FINAL PLAT

RE: SUB 2000-79 -- One-Step Final Plat of CEDAR VIEW SECOND ADDITION

RE: SUB 2000-79 -- One-Step Final Plat of CEDAR VIEW SECOND ADDITION

CASE NUMBER: SUB 2000-79 -- CEDAR VIEW 2ND ADDITION

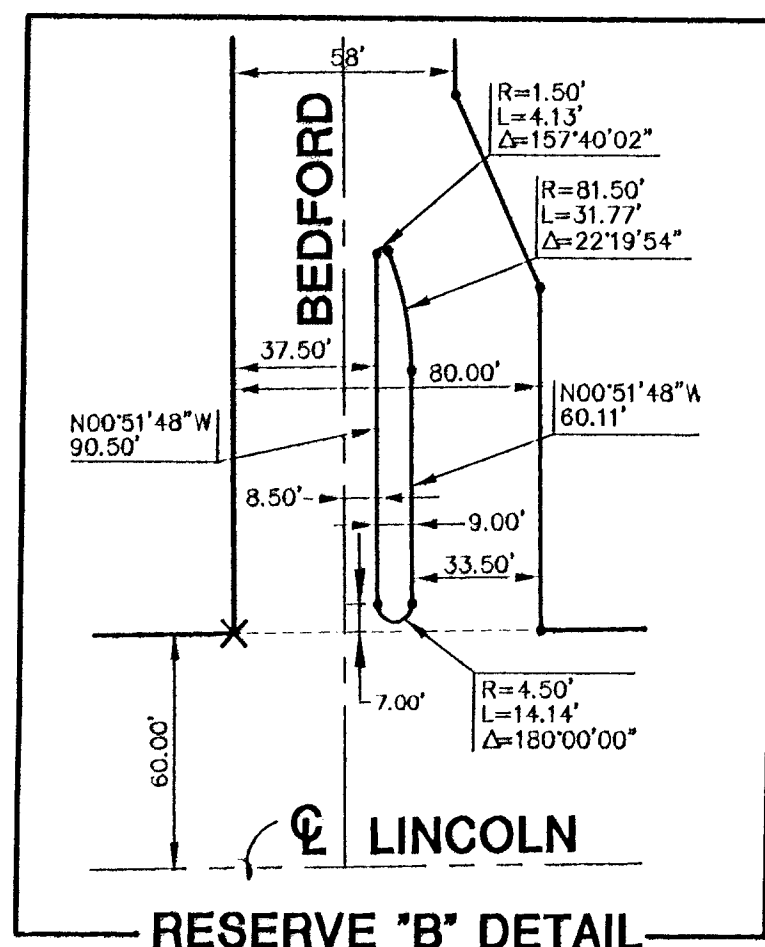
- E. City Engineering needs to comment on the status of the applicant's drainage plan. A drainage plan is needed. A minimum pad elevation needs to be platted adjacent to Reserve A.

- F. The right-of-way of the Kansas Turnpike and Condemnation Case number should be denoted.
- G. The applicant shall dedicate complete access control along the Kansas Turnpike.

- H. A minimum pad elevation should be denoted as was platted in the Cedar View Addition unless this requirement has been revised.
- I. Provisions shall be made for ownership and maintenance of the proposed reserves. The applicant shall either form a lot owners' association prior to recording the plat or shall submit a

- L. The use of Reserve A for utilities located within the platted easements should be referenced in the plat's text.
- M. The legal description should delete reference to the southwest quarter.

- N. The corner tie point should reference the "SW corner of the NW quarter".
- O. The section center should be located on the final plat tracing.
- P. A legend should be included on the final plat tracing.

- Q. City Fire Department shall comment on the acceptability of the plat's street names. *The northernmost cul-de-sac needs to be revised to Bedford Circle.*
